ADDENDUM NO. 2

Whiteland Community High School Phase 2A
300 E. Main Street
Whiteland, IN 46184

PROJECT: Whiteland Community High School Phase 2a

DATE OF ADDENDUM: May 2, 2024

SHEET 211

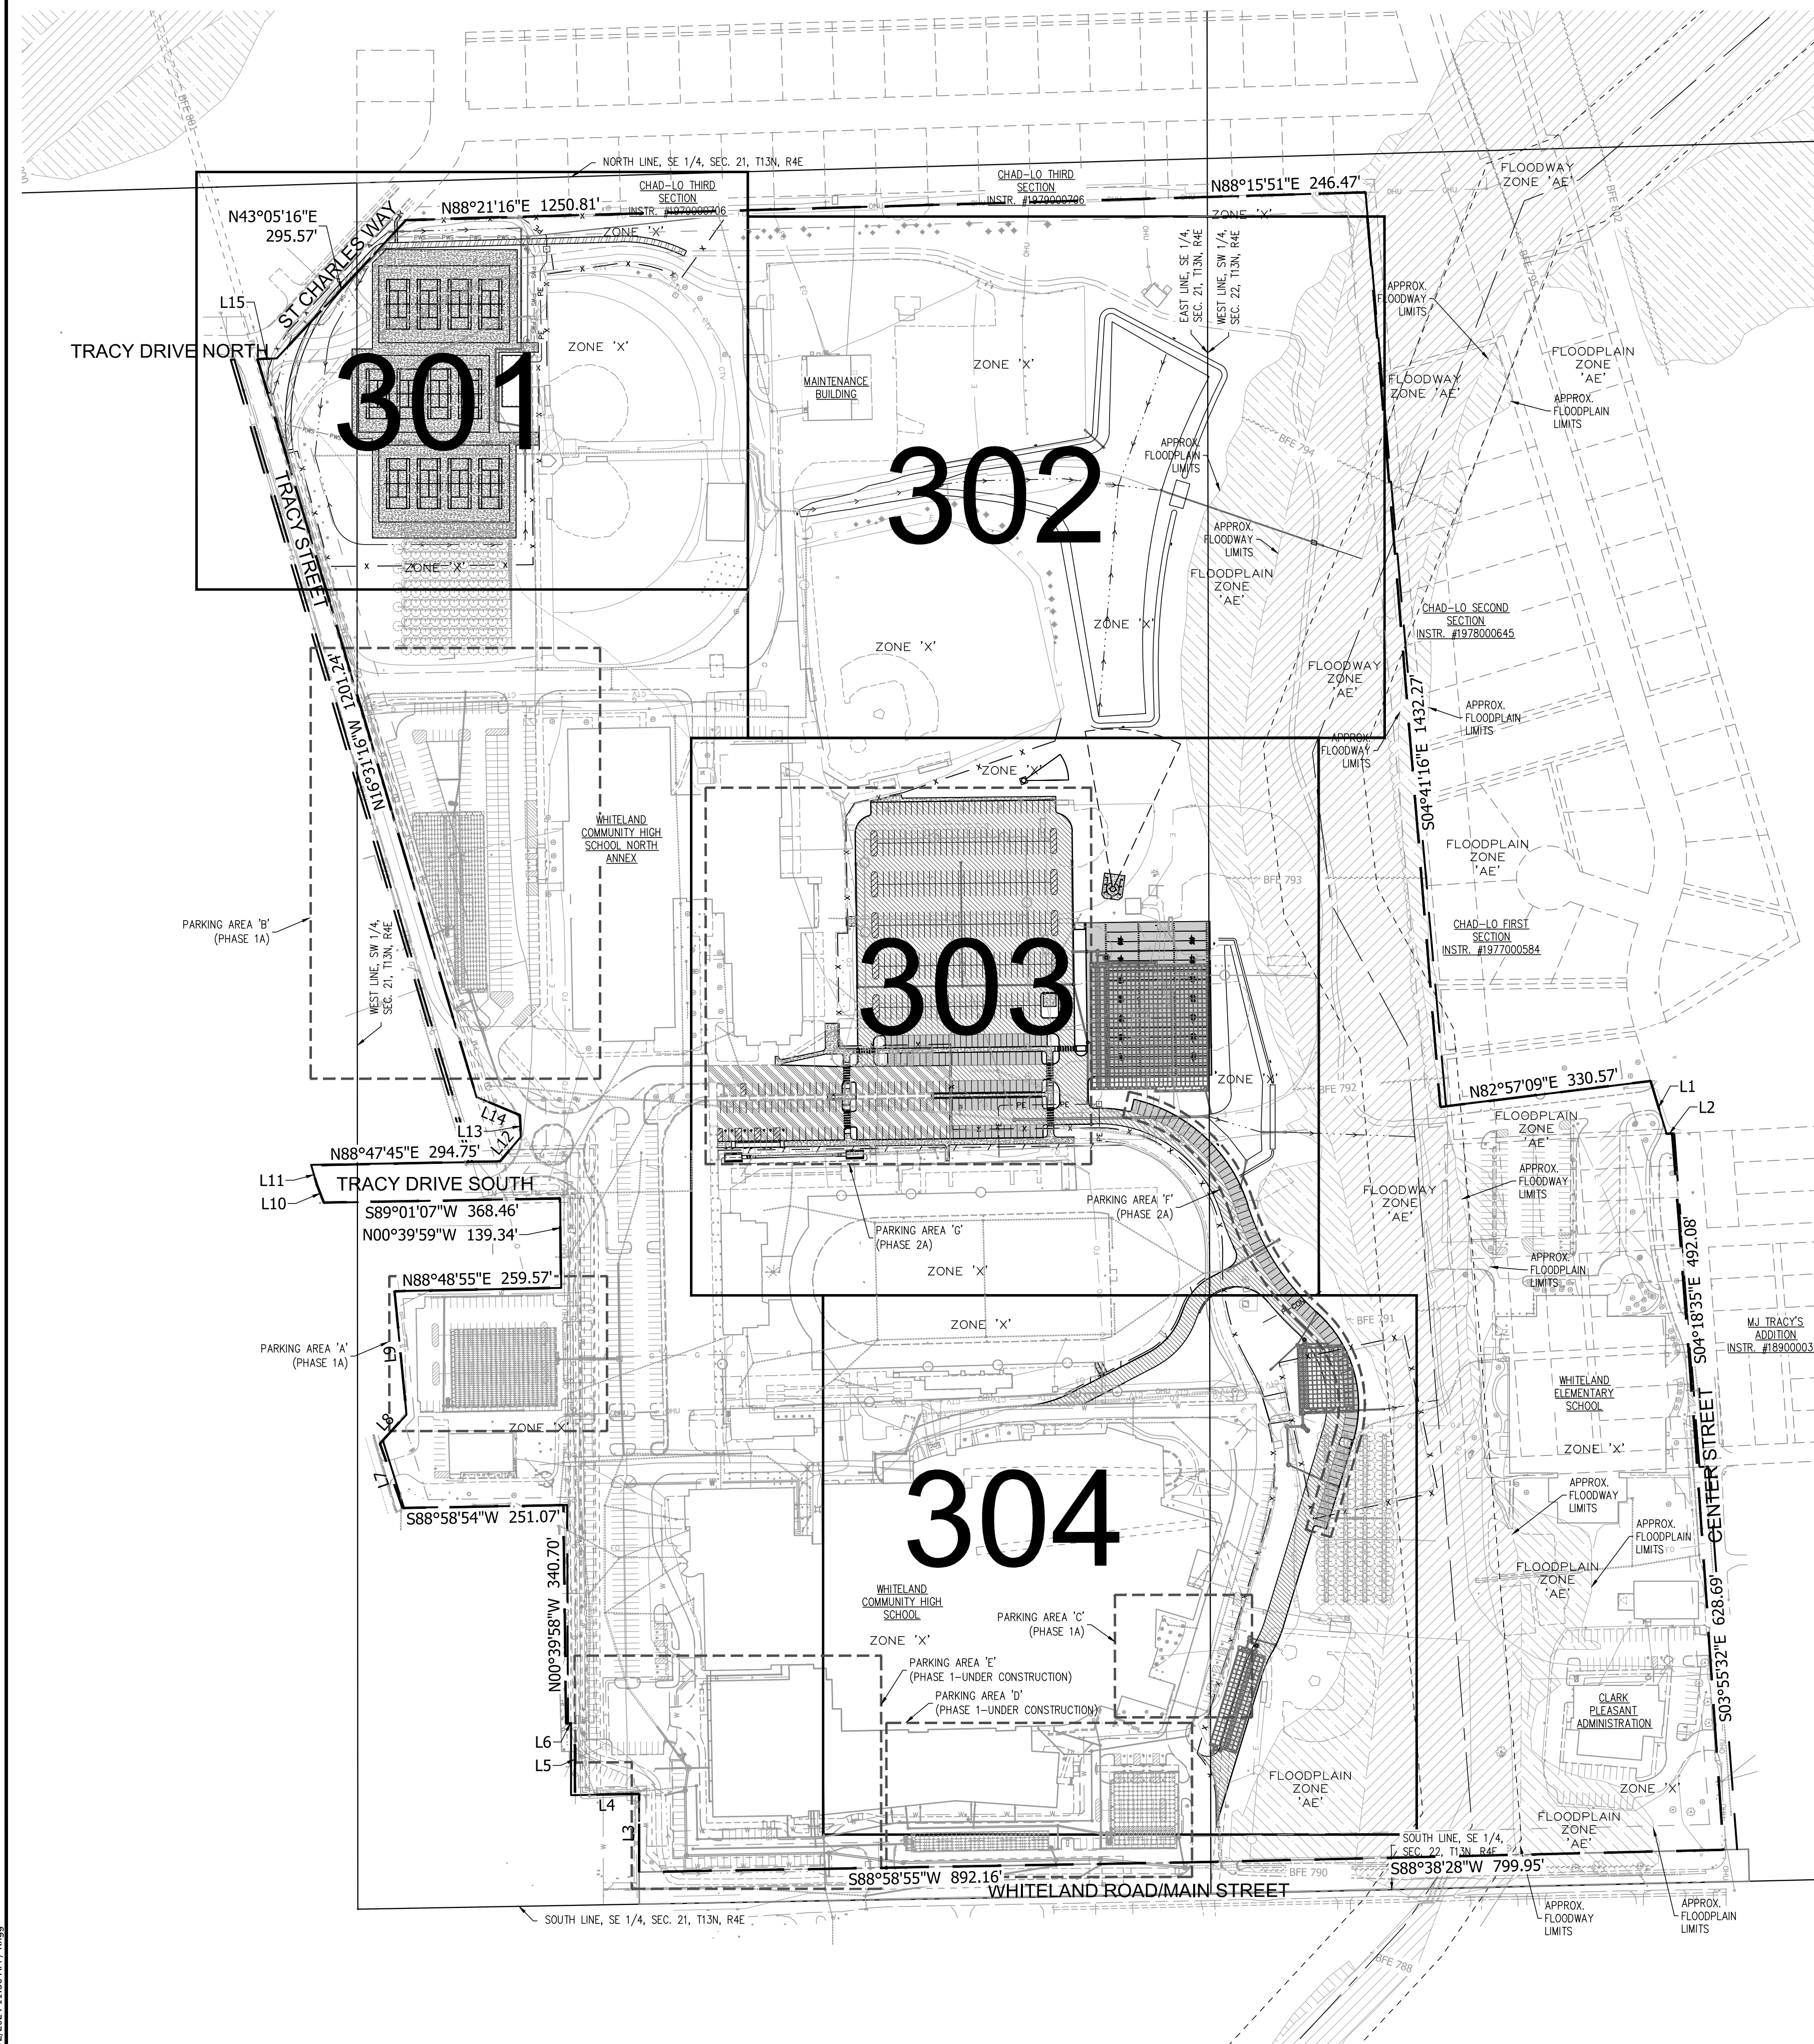
4 Site Dimension Plan (sheet 300):

- o Revised long jump location.

- o Revised to include opening length of A.D.A. parallel curb ramp near the northwest corner of the football field.

SHEET 400

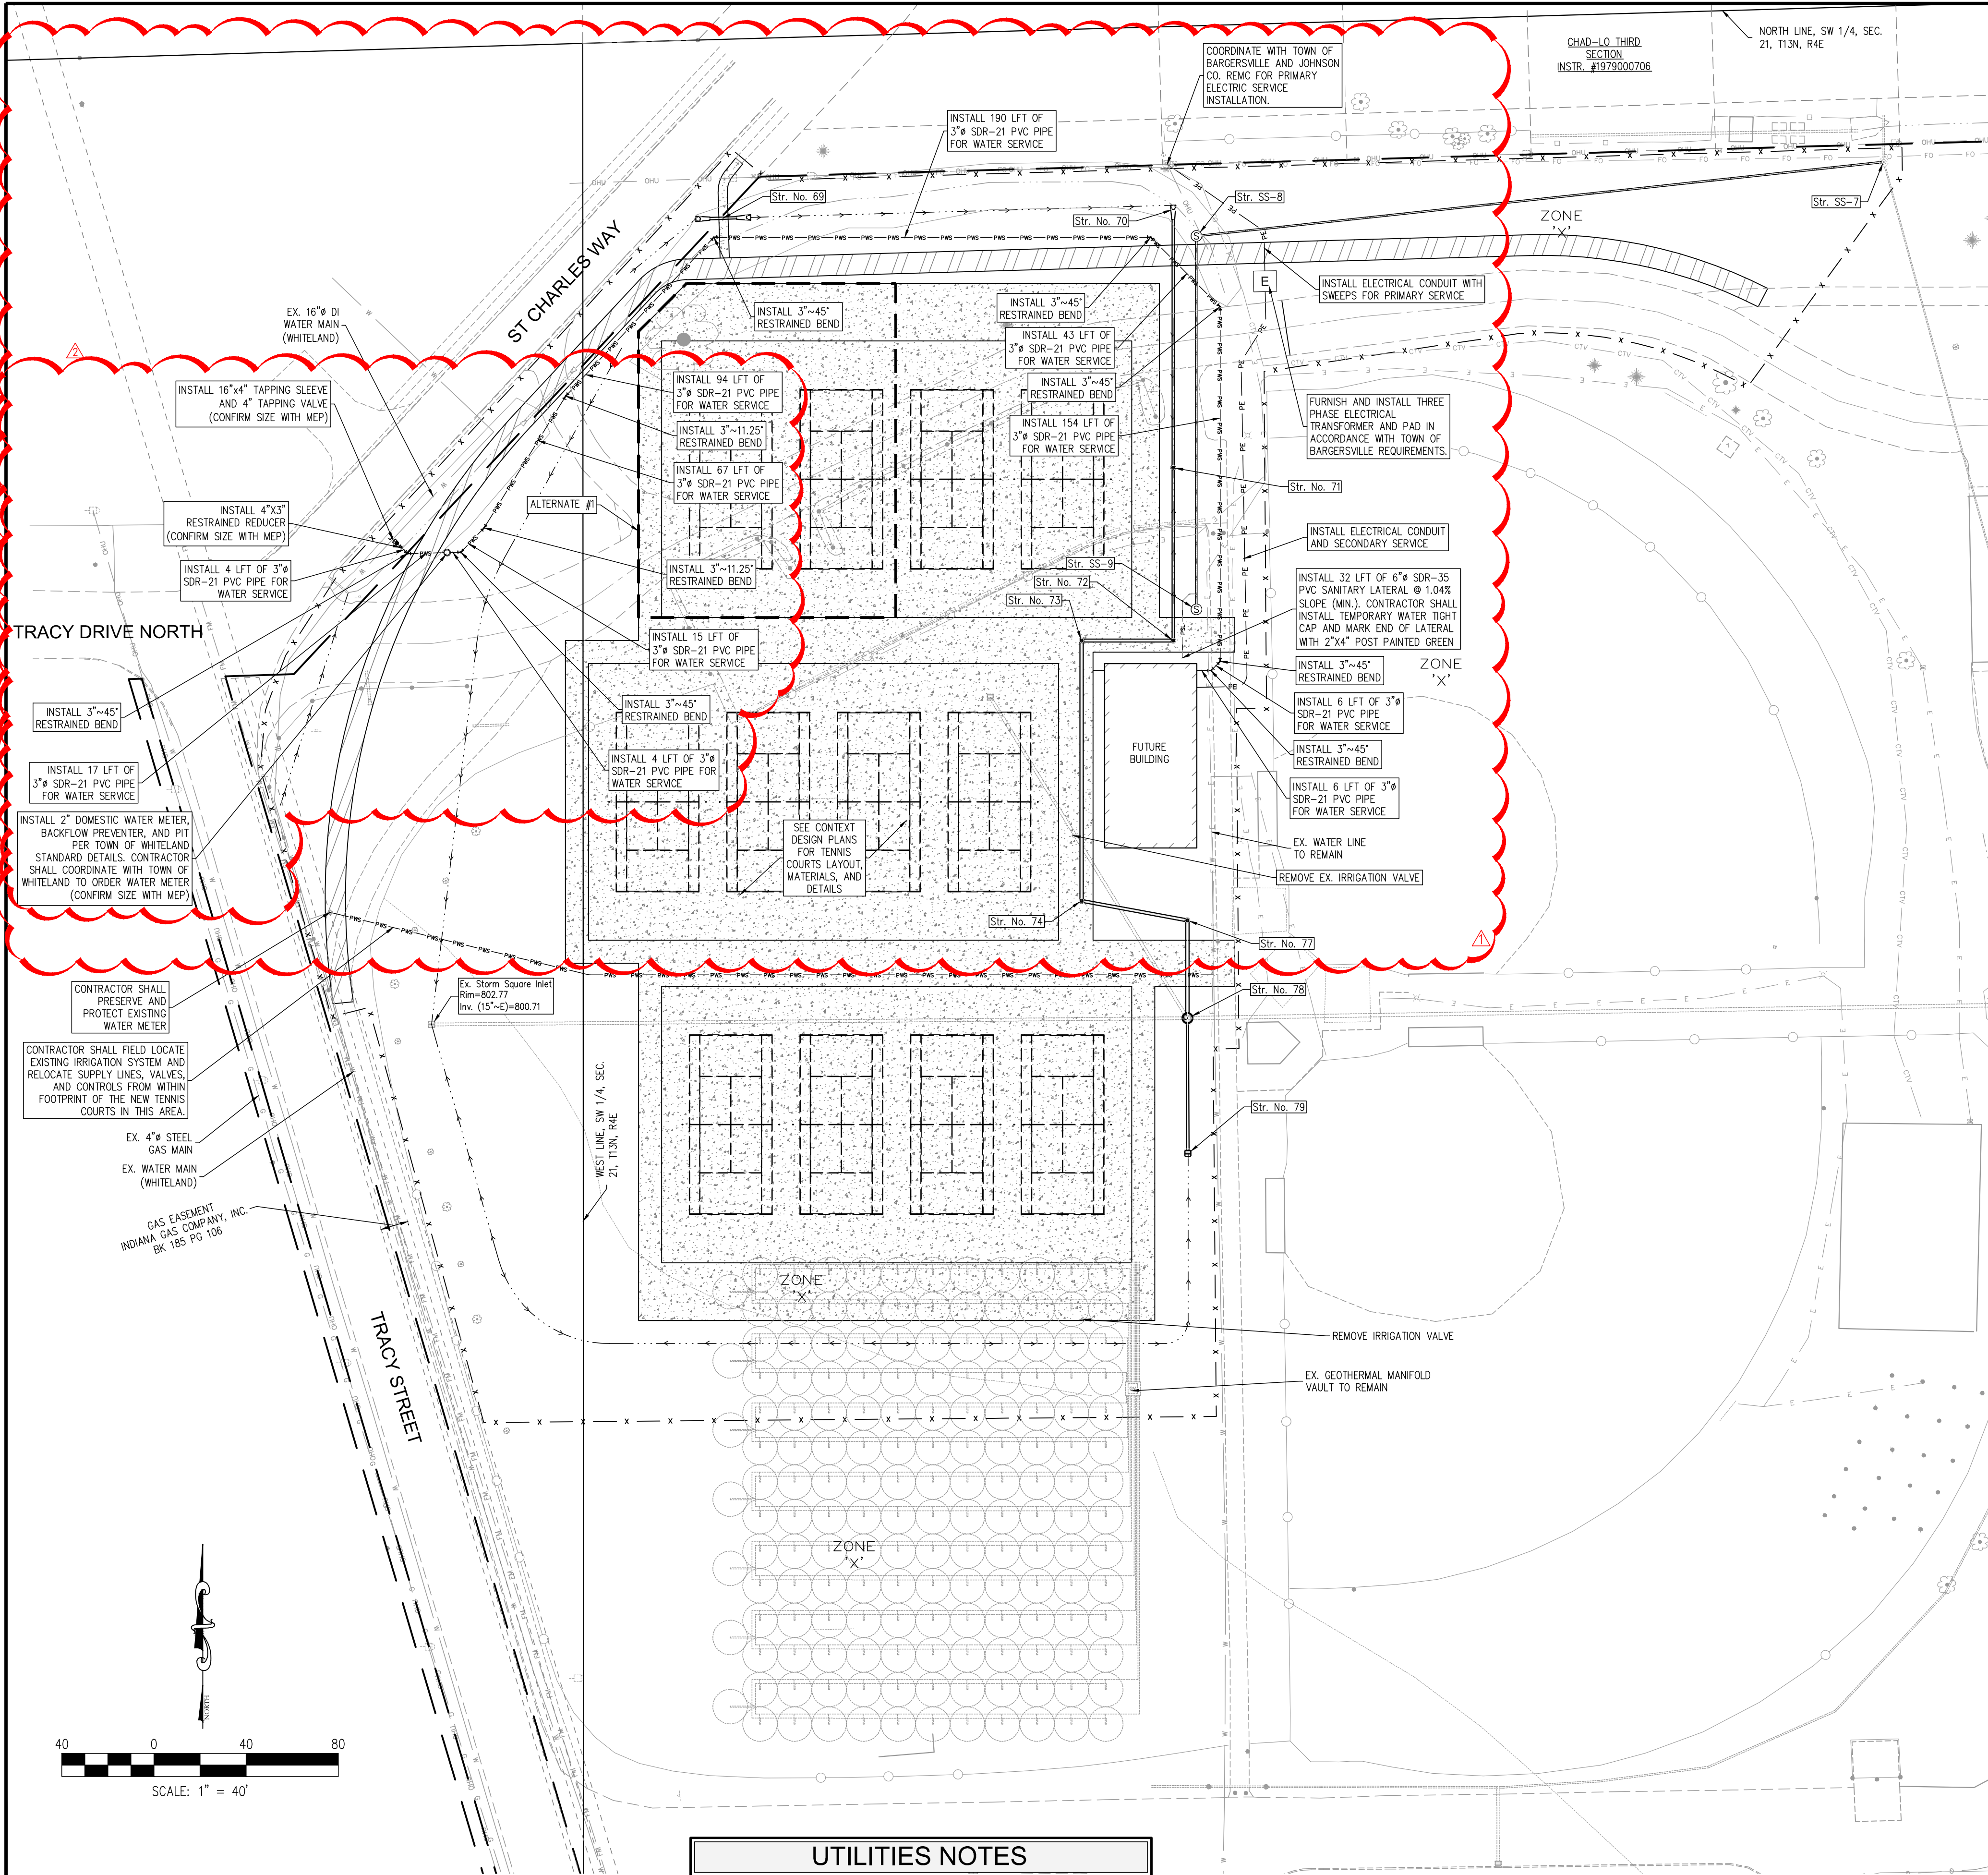
5 Utility Plan (sheet 400):

- o Revised domestic water service for future tennis building to include 16" x 4" tapping sleeve, 4" tapping valve, 4" x 3" restrained reducer, and 2" domestic meter and pit.

SHEET		403	
9			
8			
7			
6			
5			
4			
3			
2	05.02.24	REVISIONS PER ADDENDUM NO. 2 AND TOWN OF WHITELAND AND JOHNSON COUNTY SURVEYOR'S OFFICE PLAN REVIEW	DMS
1	04.23.24	REVISIONS PER ADDENDUM NO. 1	DMS
NO.	DATE	REVISIONS	BY
			APPR.

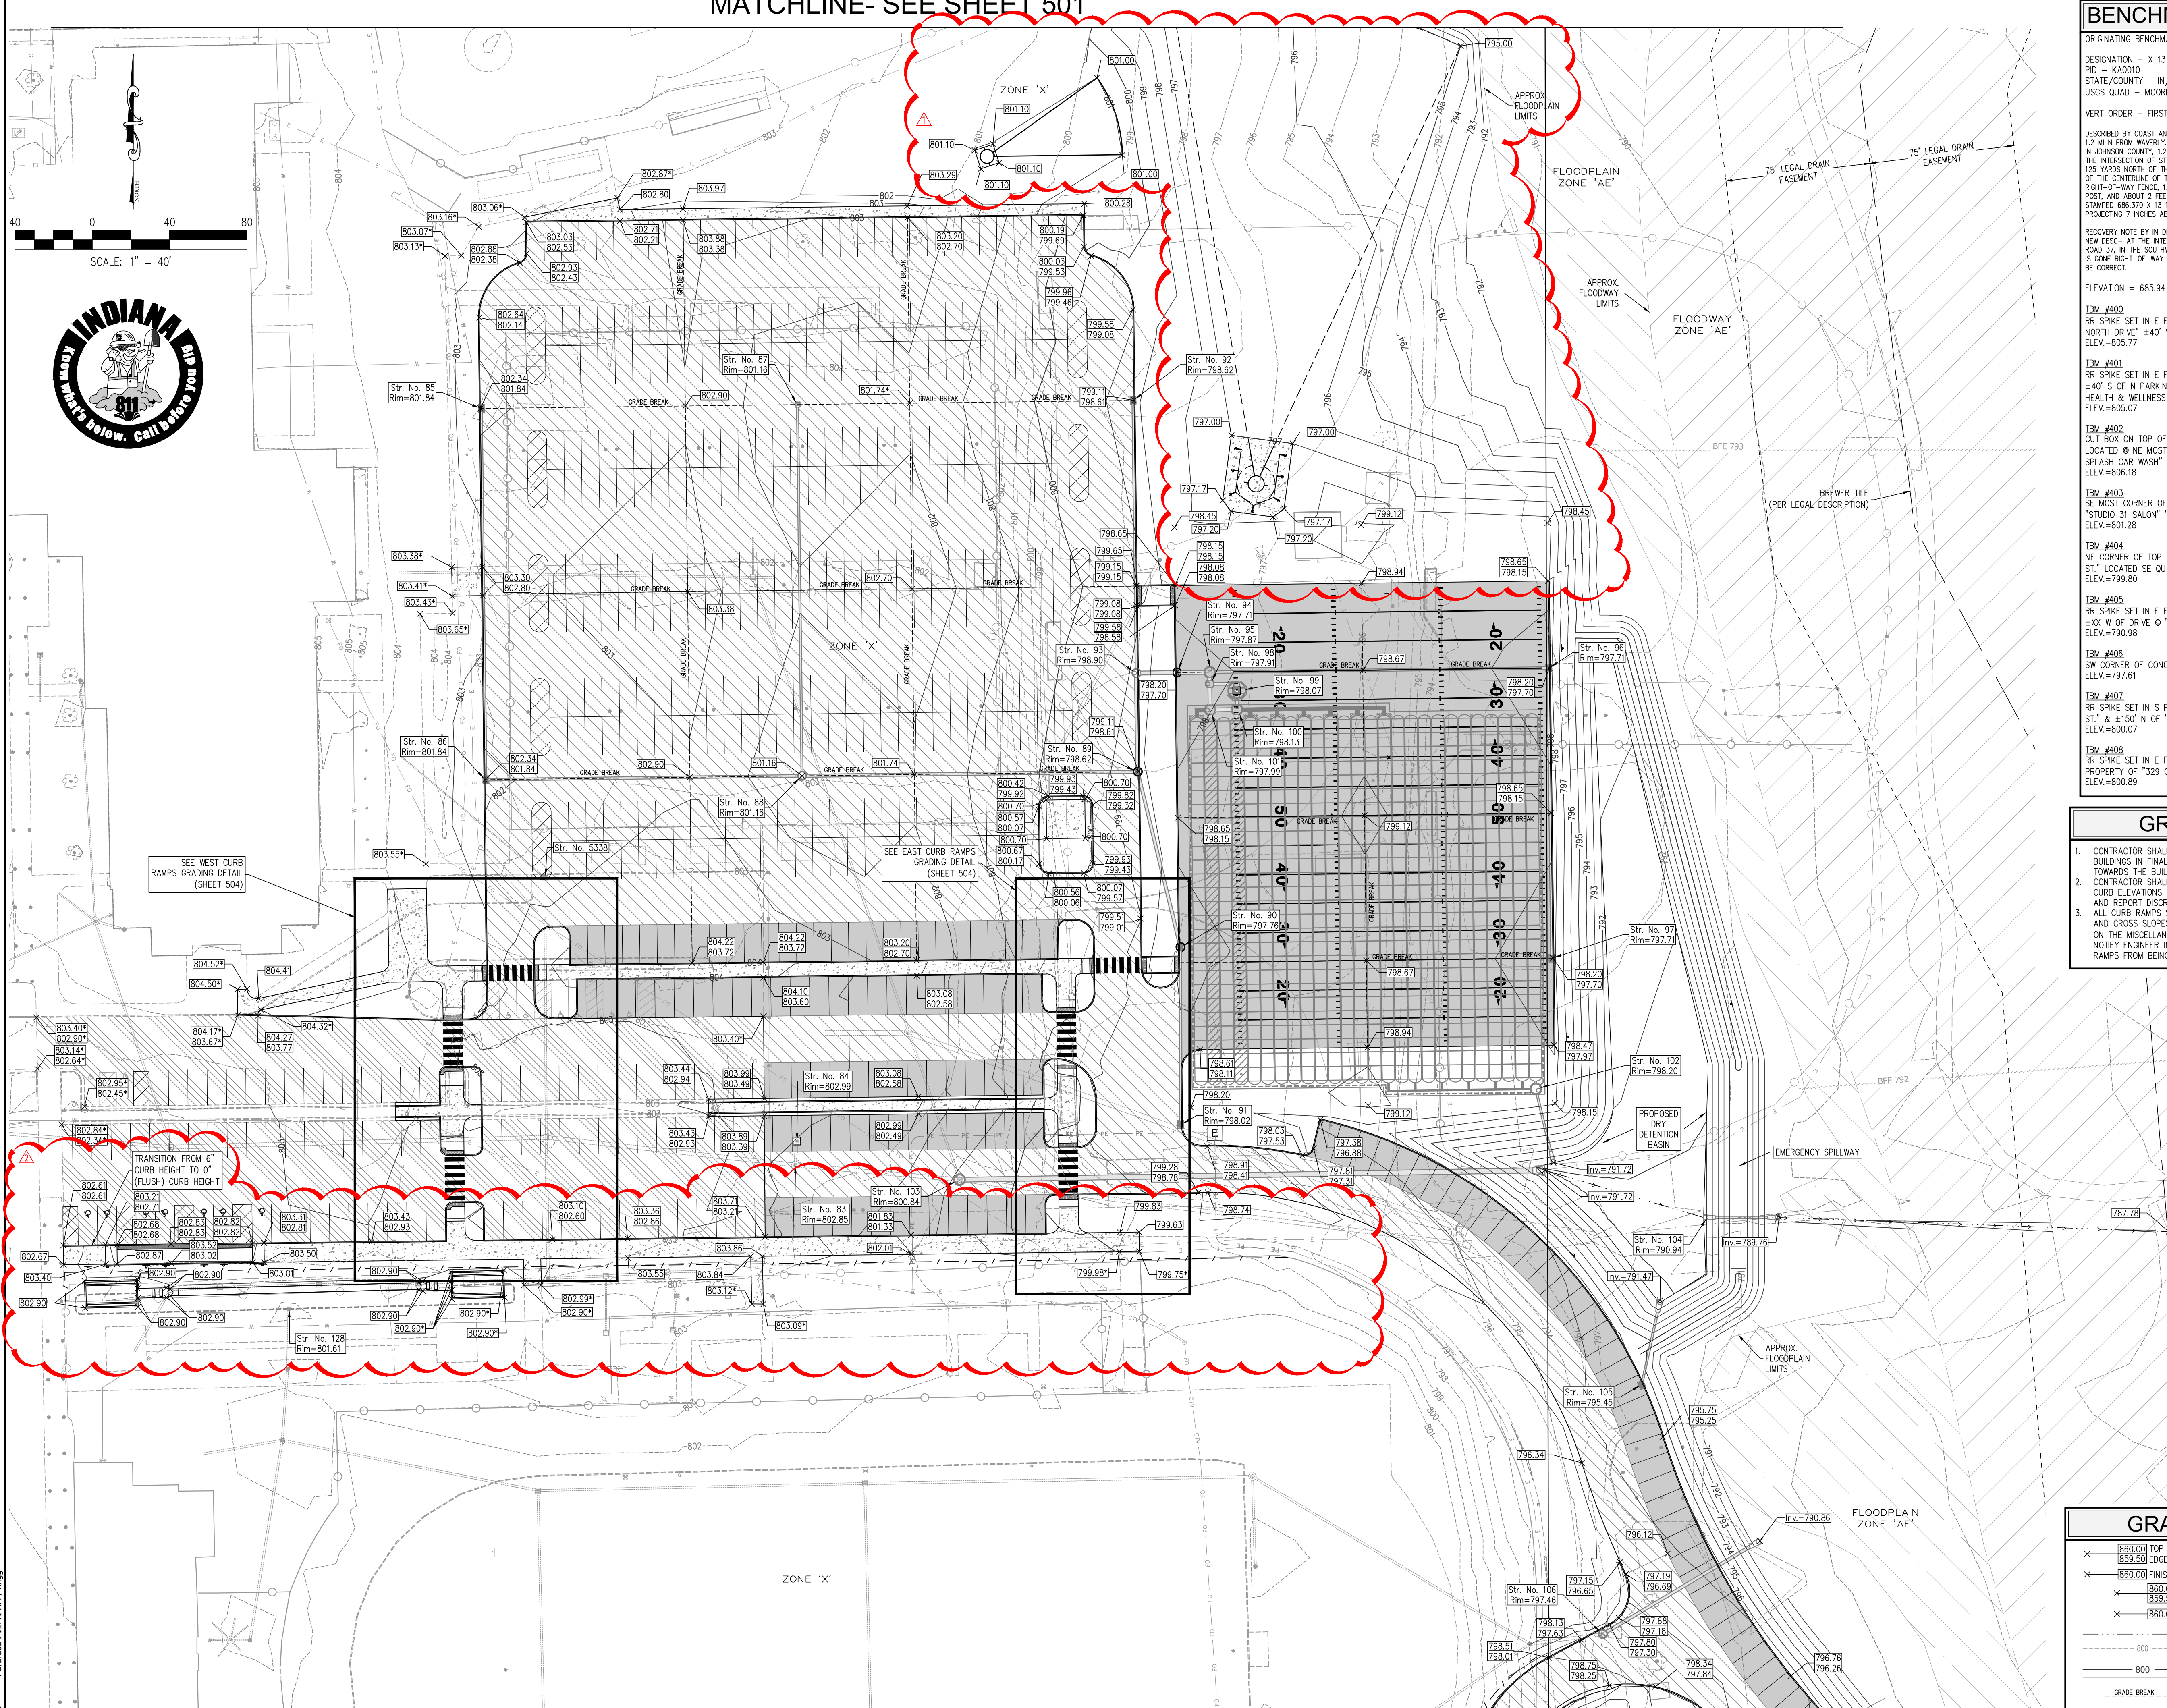
7 Utility Plan (sheet 403):

- o Revised Storm Sewer Structure Table as follows:
Str. No. 121 – revised invert elevations and slope of 24” HDPE pipe connecting Str. No. 121 and 123 as shown.
Str. No. 123 – revised invert elevations and slope of 24” HDPE pipe connecting Str. No. 121 and 123 as shown.
